DESCRIPTIVE REPORT

Field No. LJ-10-3-60 Office No. H-8520

Locality Vicinity of Sucia Islands

Inspection Report

Chart - 6380

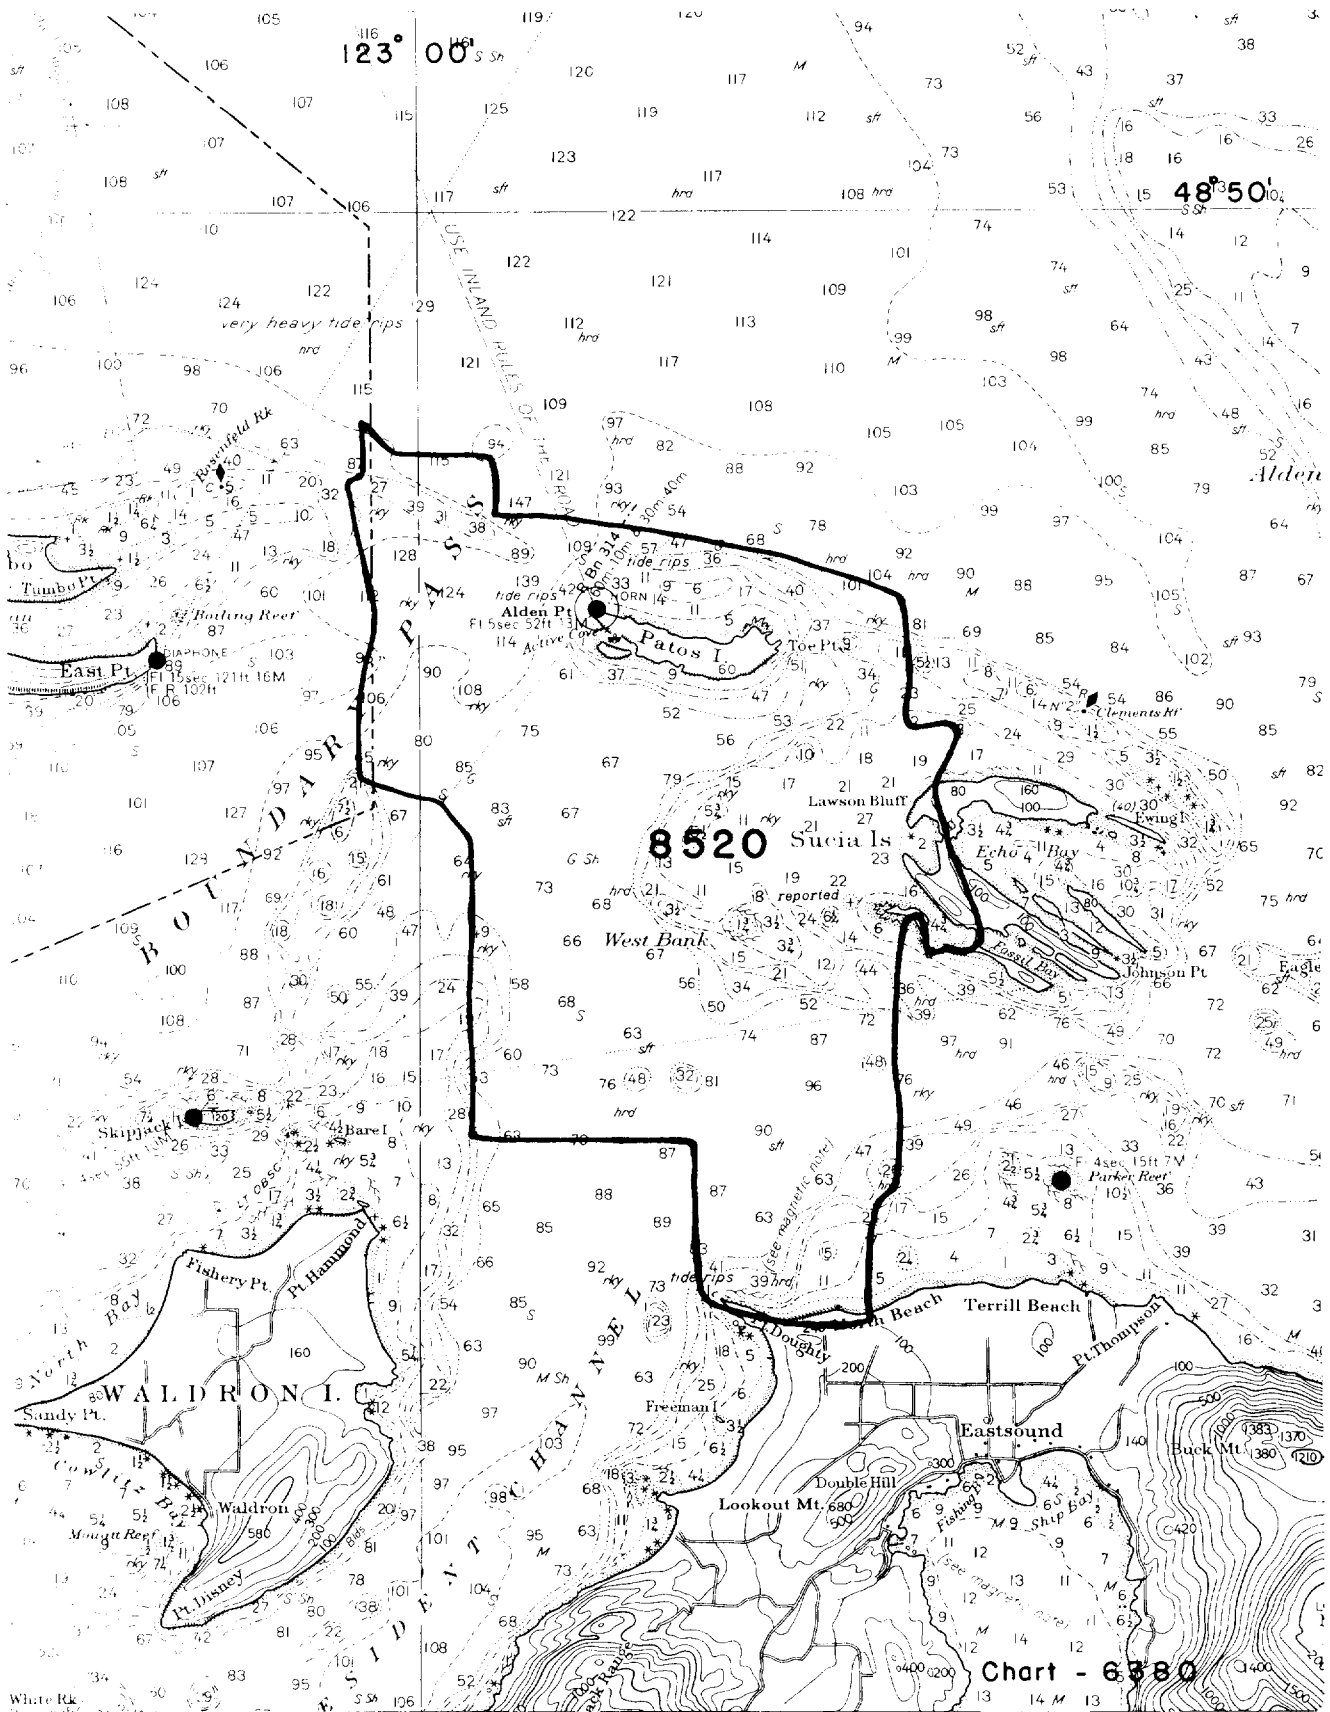
This survey has been compared with Chart 6380, 10th Ed., July 31/61 and found in reasonable agreements, though a number of shoaler soundings were found on the new survey. ✓

The charted sunken rock symbol at Lat. 48° 45'.4, Long. 122° 55'.7 falls in about ~~20~~ fathoms of water, and probably should be about 200 meters to the east. ✓

There is a 40 fathom channel just east of Patos Island that goes all the way through between Toe Point and the charted 9 fathom shoal to the east. ✓

The configuration of West Bank is different on the smooth sheet. ✓

See section of Chart 6380 attached to this report. ✓
